## INSTRUCTIONS FOR REPLACING OIL SEAL IN SCRAMBLER PINION CASTING ASSEMBLY

# UNIT POLE MODIFICATION

# SAFETY      BULLETIN

# INSTALLATION OF OVERSPEED SWITCH FOR ALLIS-CHALMERS ENGINE

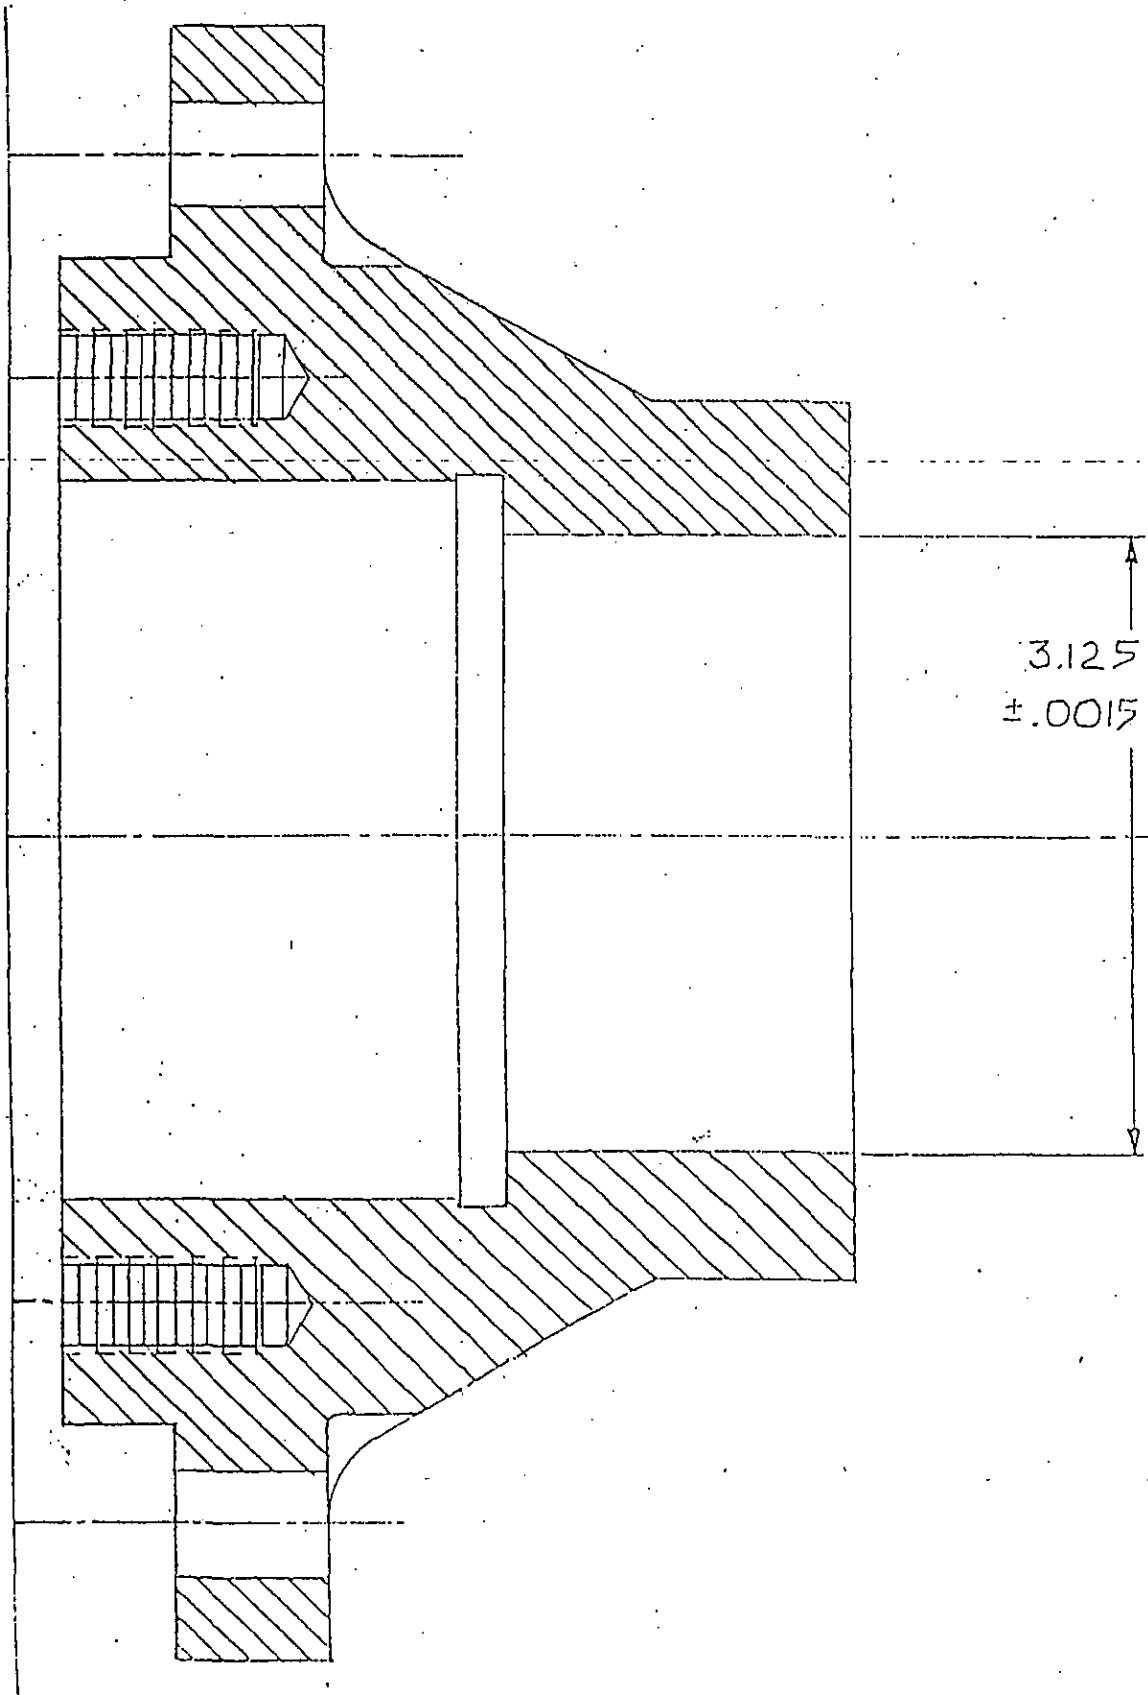
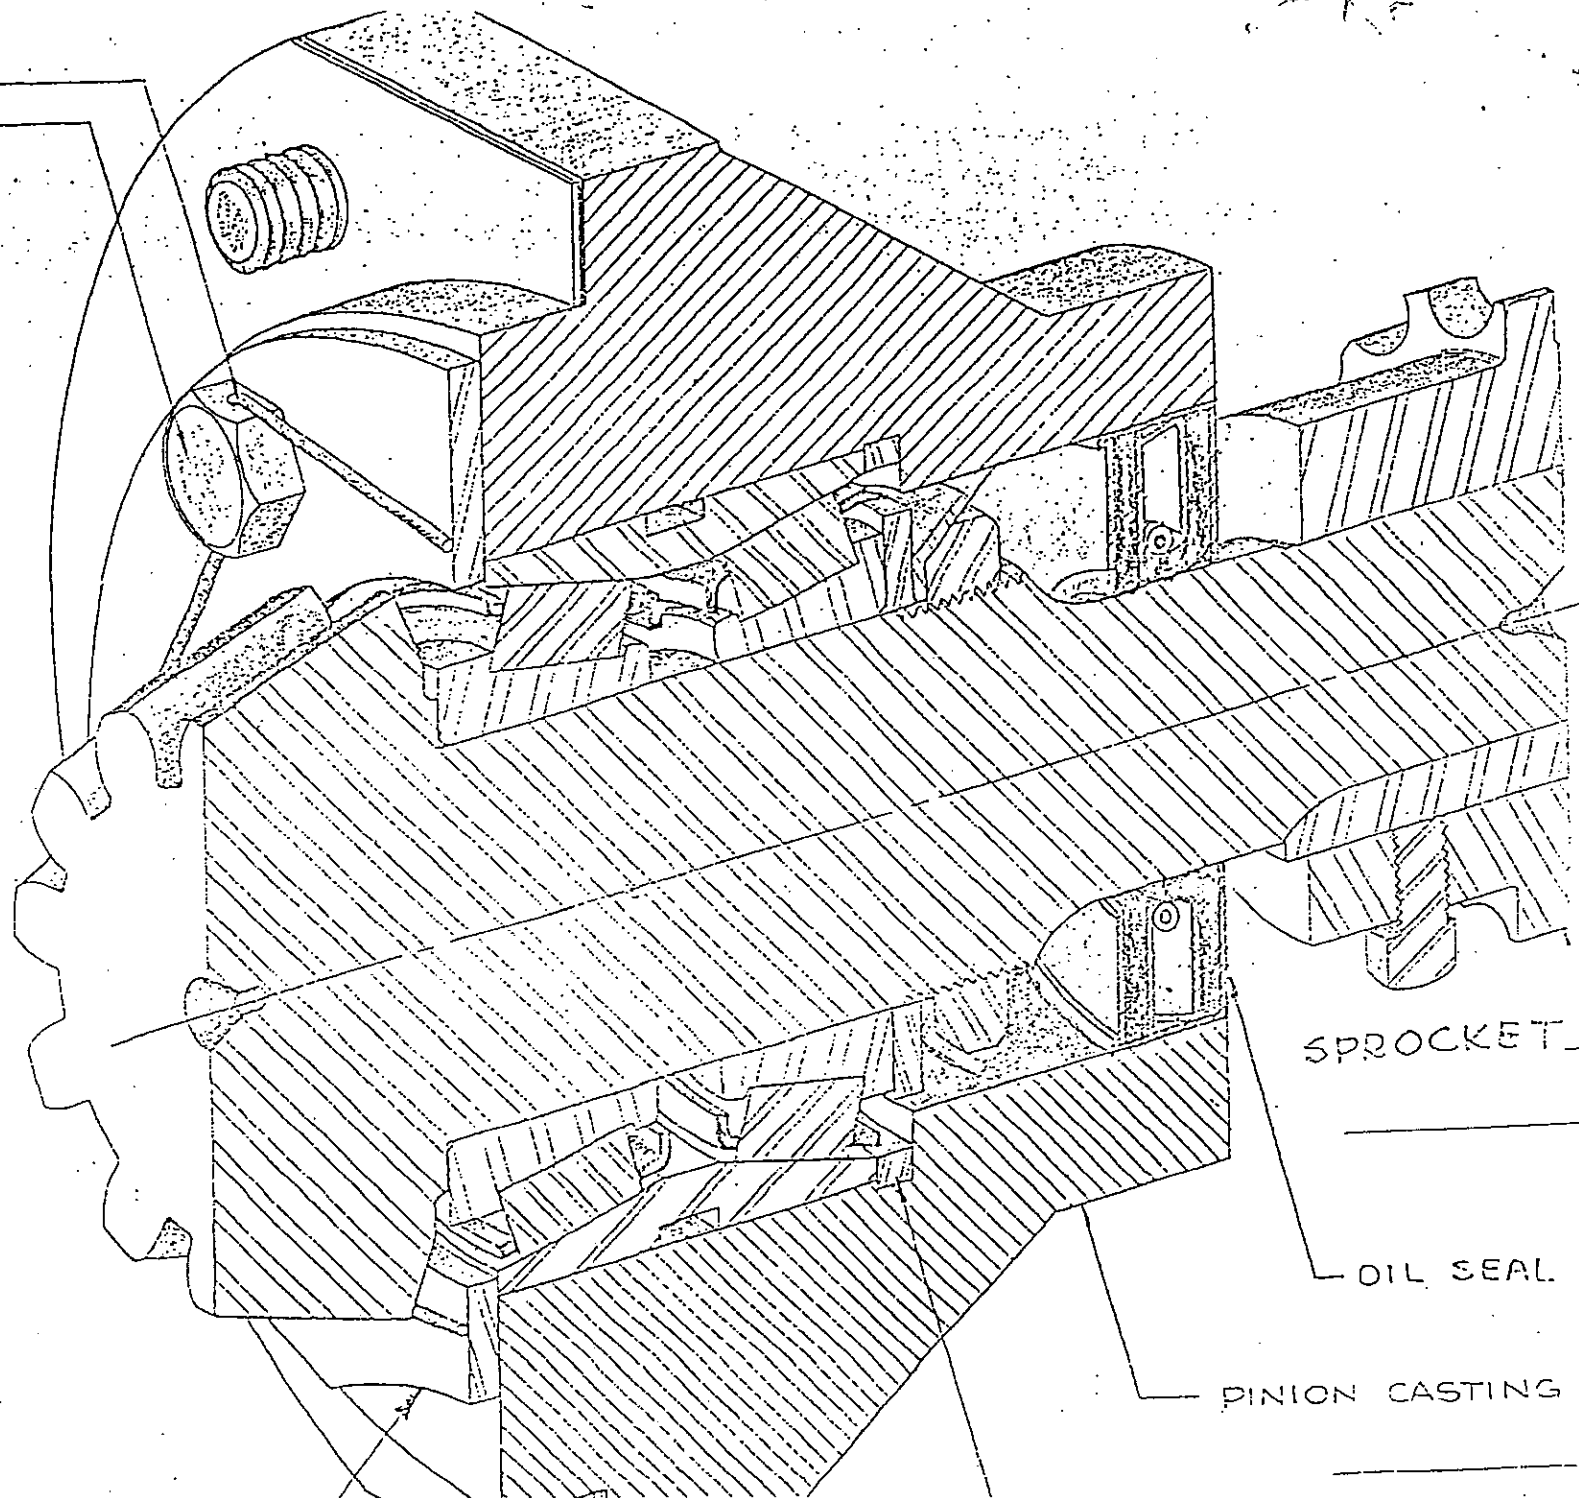
The original seal used in the pinion casting assembly was a Chicago Rawhide "Perfect" oil seal Part No. 15245. The manufacturer discontinued that seal, and we could not find an interchangeable replacement from any other manufacturer. The closest seal in size was a Chicago Rawhide Part No. 15250. The original seal had an outside diameter of 3.066", and the replacement had an outside diameter of 3.130".

Therefore, to replace the seal it is necessary that the pinion casting assembly be disassembled and the casting re-bored to  $3.125" \pm .0015"$ .

1. Remove the pinion casting assembly from the Scrambler, by taking out the six cap screws that secure it to the stationary base gear pot cover plate.
2. Remove the chain sprocket from the end of the shaft.

3. Remove the locking wire. It is 19 gage, dead soft iron wire, two feet long. When the time comes to replace it, thread the wire through the bolt heads so that loosening of the bolt will cause the wire to tighten, and then twist the ends of the wire together tightly with four turns to keep it from unwinding.

4. Remove the six cap screws that were wired together. This releases the flat ring bearing retainer so that it can be removed from the casting along with the bevel pinion gear, bearing, hardened washer, lock washer, and adjusting nut. All of these parts come out together and do not need to be disassembled.

5. The snap ring stays in the casting and is not to be removed.
6. The casting can then be re-bored to  $3.125" \pm .0015"$ .
7. Then, re-assemble all the parts, and install it on the Scrambler

The pinion casting was originally machined by gripping the casting at the small end in a three-jaw chuck. All the turned faces on the casting were finished from that one setup except for the facing off of the small end, and that was done after the rest of the machining was completed by reversing the casting in the chuck and gripping it on the large diameter locating shoulder. To re-bore the casting to the new larger diameter, grip the casting in a three-jaw chuck on the large diameter as if you were going to face off the small end. Check the original seal diameter with a dial indicator to be sure that the bore is running true before re-boring to  $3.125" \pm .0015"$ .

## TYPICAL MOUNTING DETAIL SINGLE TAB BUSHING

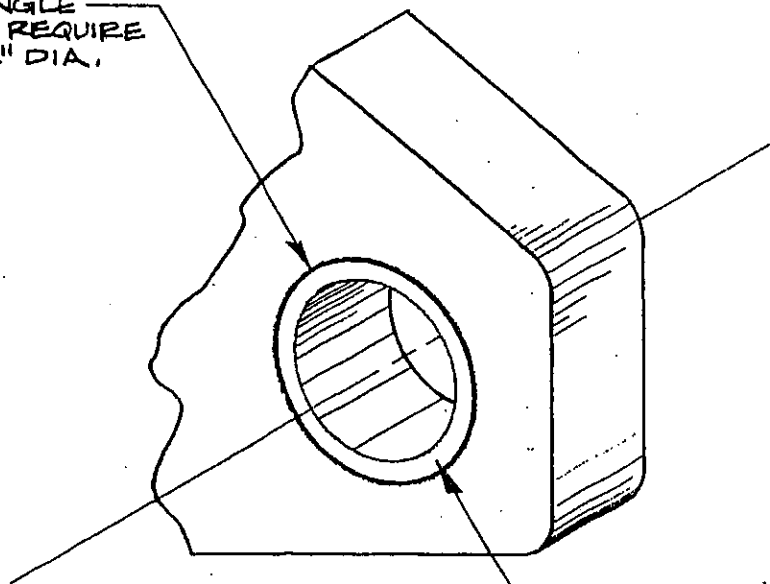
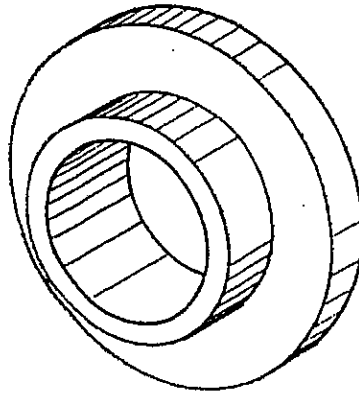
- \* TYPICAL INSTALLATION LOCATIONS ARE NOTED IN YELLOW ON ENCLOSED SCRAMBLER INSPECTION LIST.

1 LINE REAM ALL SINGLE TAB HOLES THAT REQUIRE BUSHINGS TO  $1\frac{1}{4}$ " DIA.

BUSHING IN PLACE -  
SILVER SOLDER -  
BOTH SIDES OF TAB

## TYPICAL MOUNTING DETAIL DOUBLE TAB BUSHING

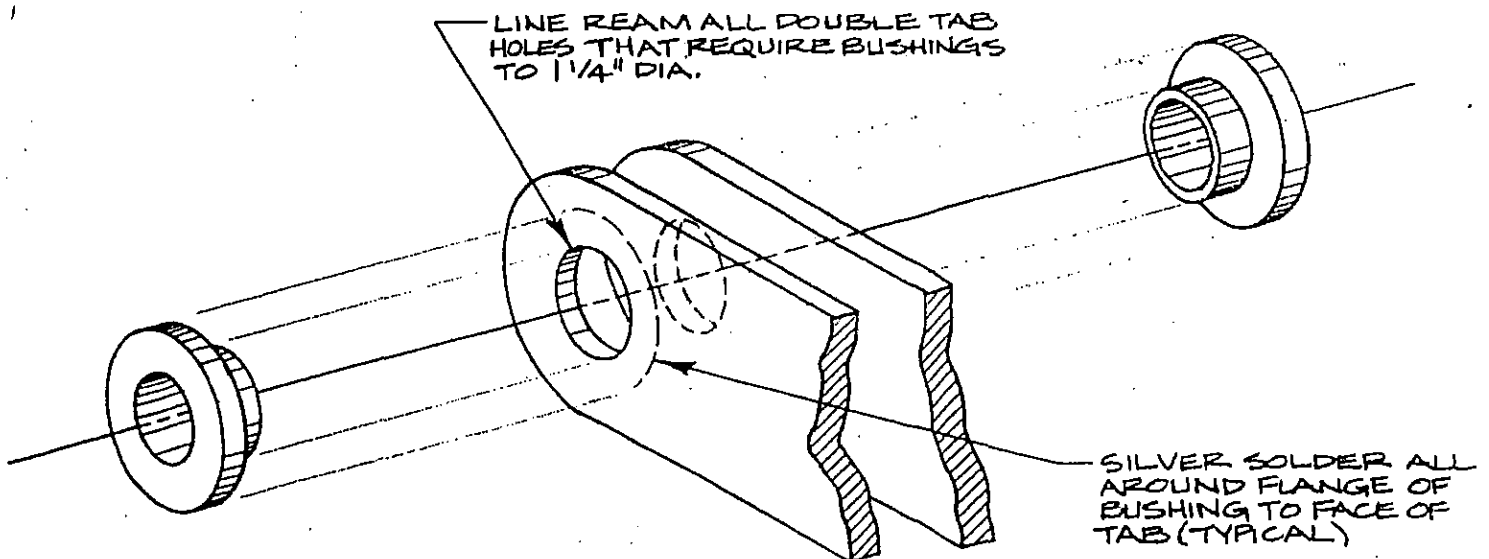
- \* TYPICAL INSTALLATION LOCATIONS ARE NOTED IN RED ON ENCLOSED SCRAMBLER INSPECTION LIST.

## LAP BAR FOR SCRAMBLER SEAT

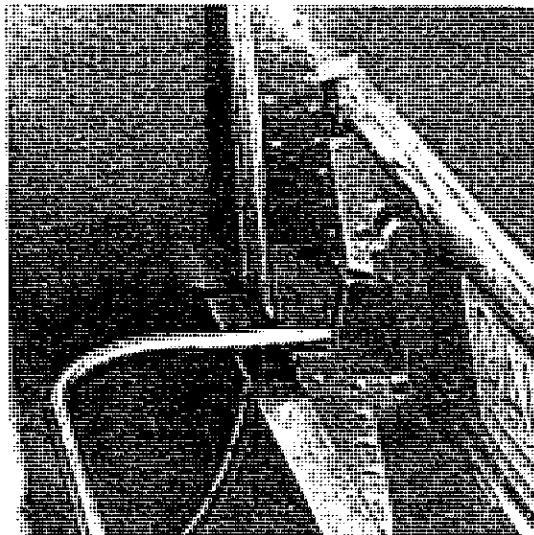
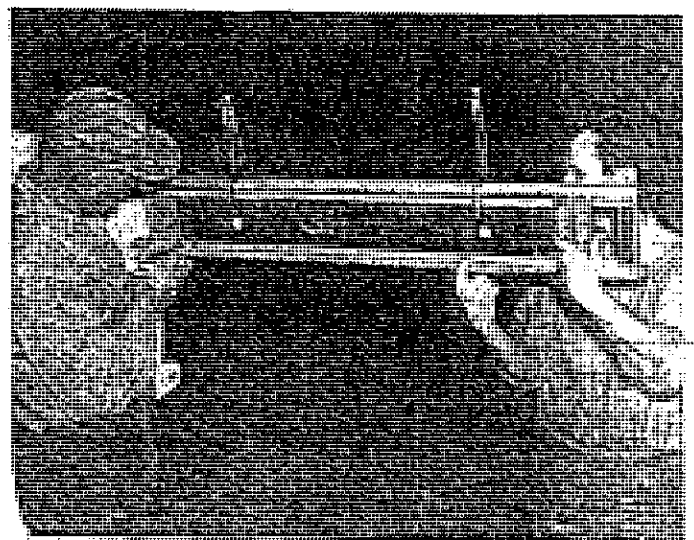
A number of Scrambler owners have expressed interest in a lap bar for the Scrambler seat. Accordingly, all 1965 Model Big Eli Scramblers will be fitted with lap bars, and Eli Bridge Company will supply at reasonable cost a modification kit to enable any earlier Scrambler owner to install lap bars on his Scrambler seats if he wishes to do so.

and will not need painting. The bar turns freely on hinge pins in nylon bushings. It can be used in the low position, as shown in Picture No. 1, where small children can grip it easily and securely, or it can be swung up as in Picture No. 2 to provide more room for stout passengers. Rubber bumpers cushion the lap bar in both the upper and lower positions so that there is no metal-to-metal contact. An additional rubber bumper added to the footbottom prevents the lap bar from hammering on the footbottom when the footbottom is folded inside the seat for transportation. See Picture No. 3.

Installing the lap bar is a very simple matter. All that is necessary is to drill eight holes in the handlebar (as shown in Picture No. 4), drill two holes in the footbottom, and then bolt the parts in place. Complete installation instructions will be provided with the modification kit.
